# IWG-DPPS-25-07

## Background on preamble proposal for GV Models

# GV model Check – Occurrence of Bottoming in rigid impactor simulation

### SUV AM50 50km/h (at the start of bottoming)

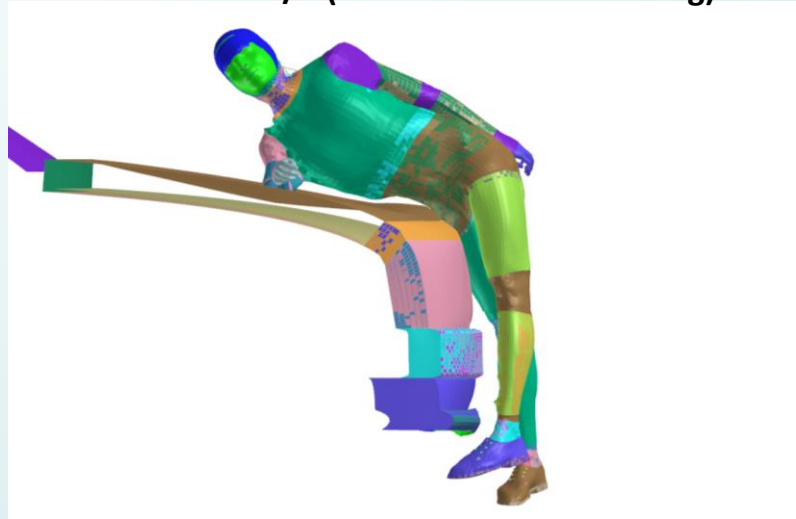
**At the time when the compression ratio of foam is 80% (80mm stroke)**

\*Since stopper is set at 89 mm stroke, bottoming is occurred by the characteristic of foam material

- **The influence of occurrence of bottoming on the head impact location and the HIT is unknown**
- **The influence may become larger due to the early start of the bottoming in SUV**
